**WPCP WASTE ACTIVATED SLUDGE UPGRADES
 PROJECT NO. 08-593-52-230**

CITY OF SAN LEANDRO

ADDENDUM NO. 3

November 6, 2008

WPCP WASTE ACTIVATED
 SLUDGE UPGRADES
 POLYMER BUILDING
 ELEVATIONS

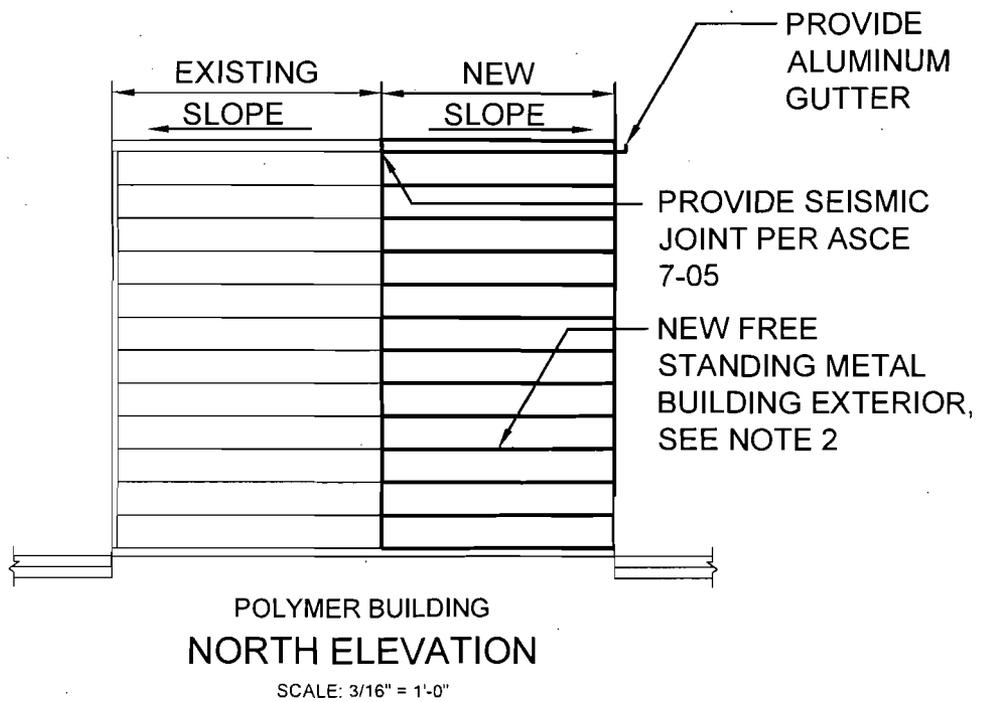
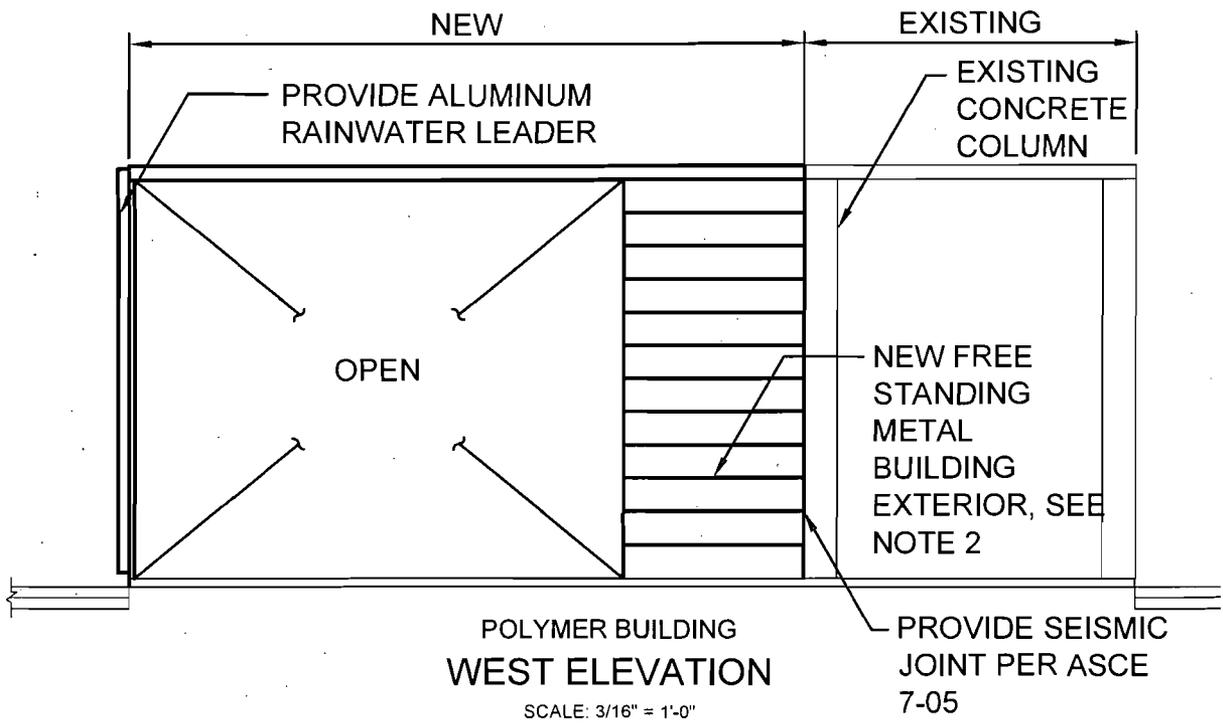
Addendum Item	Document	Section or Drawing	Description
3.08	Drawings	DWG 706	<p>Delete the following Note 2 in its entirety: "NEW METAL BUILDING EXTENSION SHALL MATCH EXISTING METAL BUILDING. SEE SPECIFICATION SECTION 13121."</p> <p>AND REPLACE WITH THE FOLLOWING: "EXTEND METAL BUILDING AS SHOWN. EXISTING METAL BUILDING WAS SUPPLIED BY COVER-ALL PROTECTIVE COVERS, RIO LINDA, CA, PHONE NUMBER – 1-800-490-5665. PROVIDE STRUCTURAL AND ANCHOR BOLT DESIGN INCLUDING DESIGN CALCULATIONS FOR THE STRUCTURAL SYSTEM, ROOFING, AND CLADDING, SEALED BY A CIVIL OR STRUCTURAL ENGINEER CURRENTLY REGISTERED IN THE STATE OF CALIFORNIA. THIS IS A DEFERRED SUBMITTAL AS NOTED ON DWG 698.</p> <p>STRUCTURAL DESIGN FOR THE BUILDING SYSTEMS SHALL BE PROVIDED FOR THE FOLLOWING LOAD CRITERIA:</p> <ol style="list-style-type: none"> 1. GOVERNING BUILDING CODE: CBC 2007. 2. WIND LOAD: 80 MPH, EXPOSURE C; IMPORTANCE FACTOR I = 1.15; WIND PRESSURE COEFFICIENTS AND THE DESIGN PRESSURES SHALL BE APPLIED PER GOVERNING CODE. 3. SEISMIC: SEE SECTION 01900. 4. DEAD LOADS: SHALL INCLUDE THE WEIGHT OF BUILDING SYSTEM CONSTRUCTION, SUCH AS ROOF, FRAMING, AND COVERING LOADS. 5. LIVE LOADS: 20 PSF. <p>PROVIDE FREE-STANDING FRAME OR FRAMELESS STRUCTURAL SYSTEM WITH 24 GAGE (0.61 MM) GALVALUME STEEL MATERIAL. MATCH THE PROFILE AND COLOR OF THE EXISTING STRUCTURE. CANDIDATE MANUFACTURERS INCLUDE VARCO-PRUDEN BUILDINGS, AMERICAN DINGS, BUTLER METAL BUILDING SYSTEMS, OR COVER-ALL PROTECTIVE COVERS.</p>

Addendum Item	Document	Section or Drawing	Description
3.09	Drawings	DWG 706	See attached drawing with North and West Elevations of Polymer Building.
